PROJECT DESCRIPTION
ALTERATION OF EXISTING TENANT SUITE
WORK INCLUDES REMOVAL AND REPLACEMENT OF EXISTING MRI UNIT
ALTERATION TO EXISTING TENANT SUITE FOR NEW WORK

City of Aurora Building Division
Project: *Invision Sally Jobe*
Address: *1400 S POTOMAC ST Unit 180*
Occupancy Group: *IBC B*
Construction Type: *UBC TYPE II-N SPK*
RSN: *1368403*
Permit: *2019-1623163 -TF*

City of Aurora Building Division
Reviewed for Code Compliance
Approved as Noted: Y. MUNOZ
Date: May 16, 2019
2015 INTERNATIONAL CODES & 2017 NEC

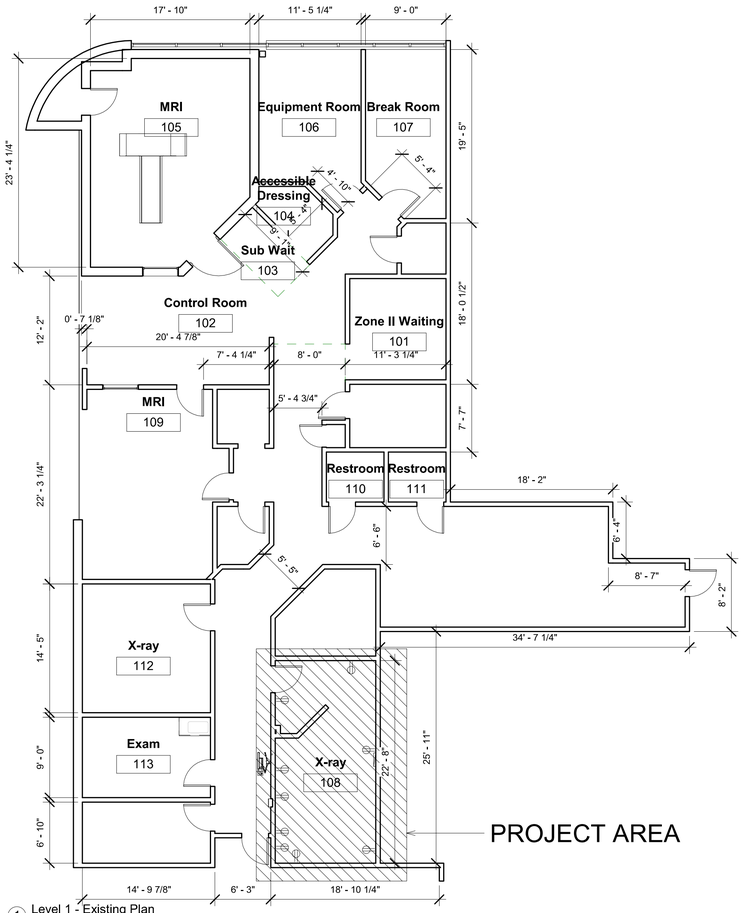
This plan is reviewed to **IBC** but the existing building is NOT converted to **IBC**. The construction type listed is **UBC.** Occupancy group is **IBC.**

SHEET TITLE
Reflected Ceiling Plan - Existing

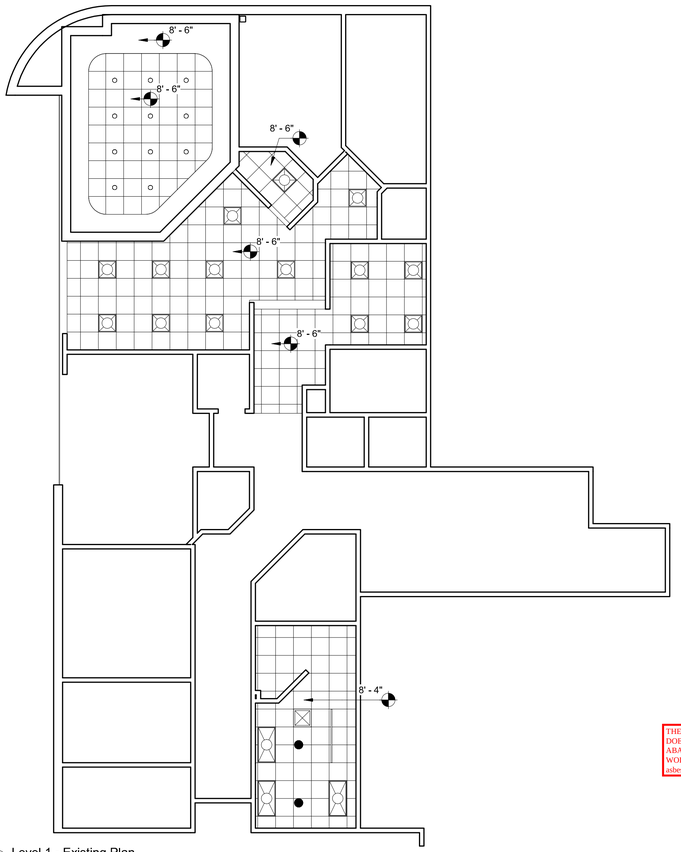
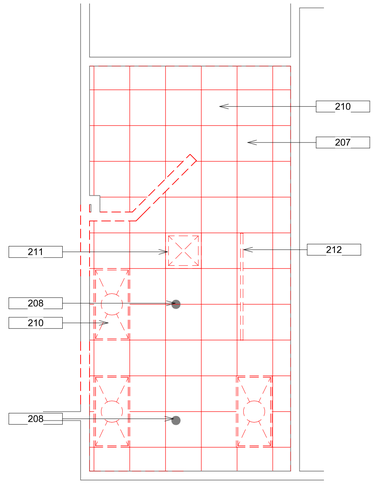
This sheet of drawings has not been reviewed for code compliance.

SHEET TITLE
Floor Plan - New

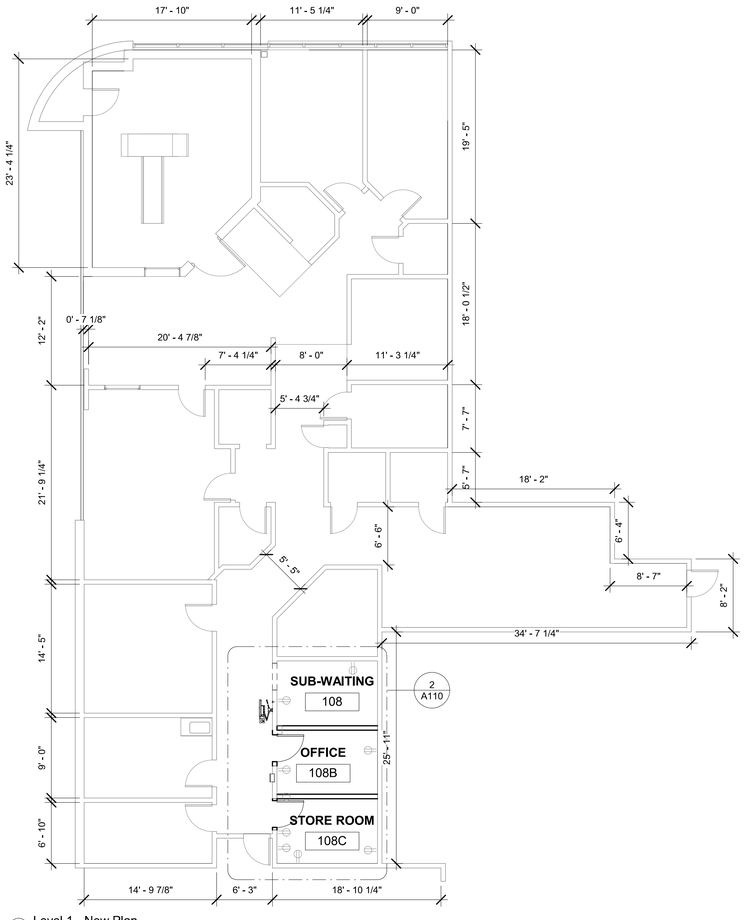
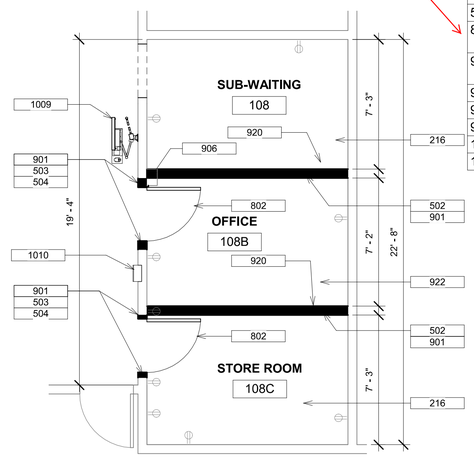
Provide lever or other approved hardware on all new and relocated doors.
2009 ICC/ANSI 117.1 309.4
